SUBJECT: Provides addl info re offsite dose calculation manual
 submitted on 850831, per 850404 request. Setpoint calculation
 for normal svc water monitor, basis for external radiation
 value & direct radiation dose estimates provided.

SHEARON HARRIS NUCLEAR POWER PLANT
UNIT NO. 1 - DOCKET NO. 50-400
OFFSITE DOSE CALCULATION MODEL

RESPONSES TO U. S. NUCLEAR REGULATORY COMMISSION REQUEST FOR ADDITIONAL INFORMATION IN REGARD TO THE SHEARON HARRIS NUCLEAR POWER PLANT (SHNPP) OFF-SITE DOSE CALCULATION MANUAL (ODCM)

FIGURE 2.1-3 NORMAL SERVICE WATER FLOW DIAGRAM

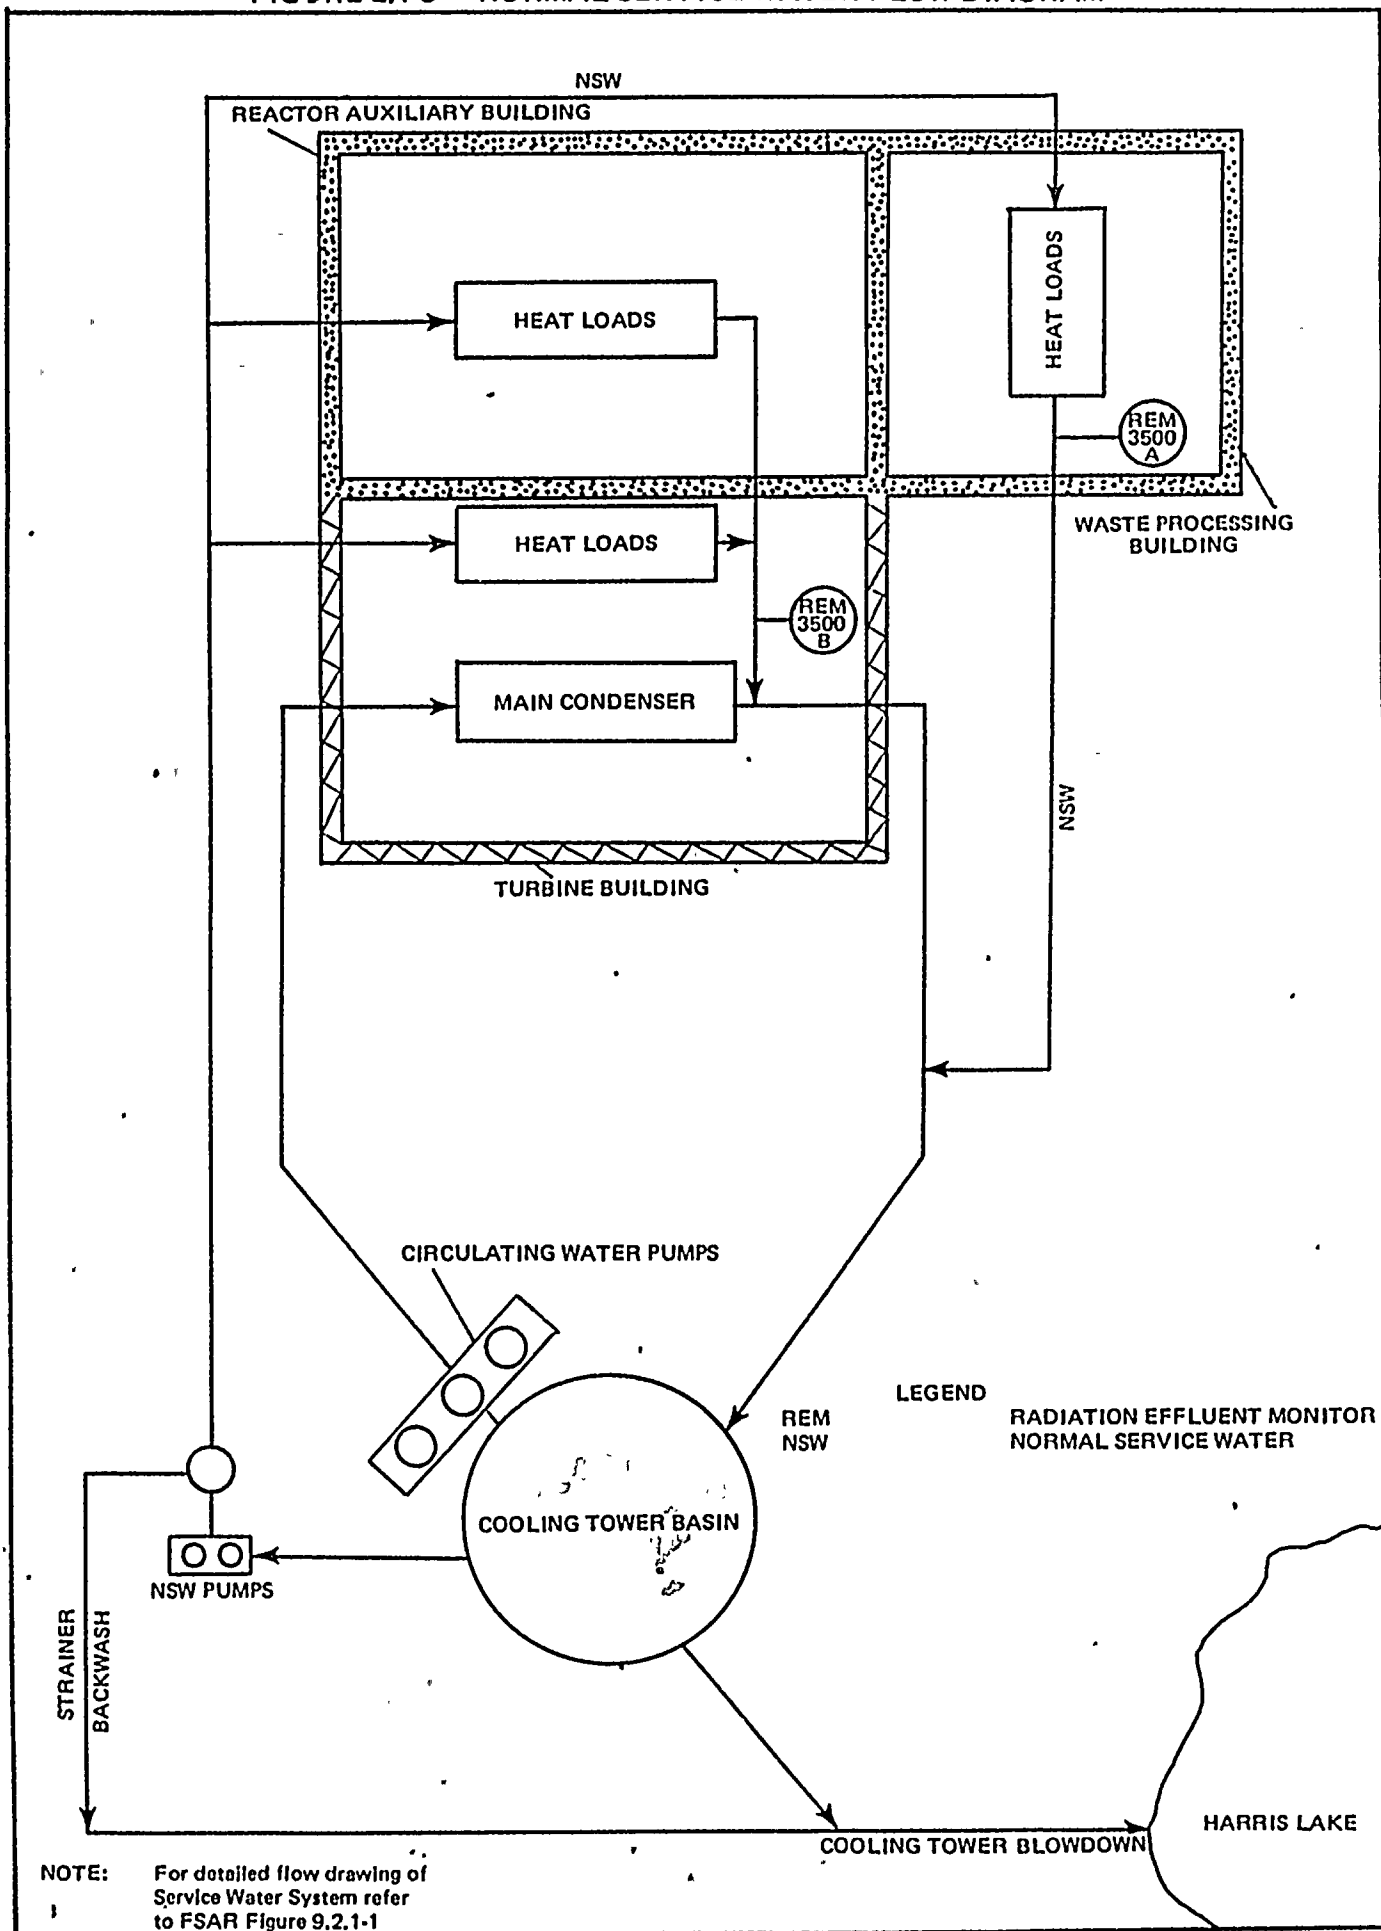
Although the Applicant indicated that the normal service water (NSW) is monitored and covered by T/S 3.3.3.0, the Applicant has not provided a setpoint calculation of such a monitor. Also, the Applicant's Figure 2.1-2 does not show such a flow path in the flow stream diagram. Provide the setpoint calculation for the NSW monitor, and revise Figure 2.1-2 as appropriate.

The setpoint for the normal service water (NSW) monitors will be determined by either of the two methods listed below:

Method 1 - This method determines the alarm setpoint using the following formula:

Method 2 - This method determines the alarm setpoint as 2 x background.

This latter technique is acceptable from an effluent release standpoint because NSW is not discharged directly to the environment and it undergoes significant dilution in the cooling tower basin. Downstream monitoring for ODCM effluent accountability purposes is provided by the continuous grab sampler in the cooling tower blowdown.

The methods listed above will be incorporated into the ODCM. To show the NSW flow paths, Figure 2.1-3 entitled "Normal Service Water Flow Diagram" will be added to the ODCM. The diagram is included here as Attachment 1.
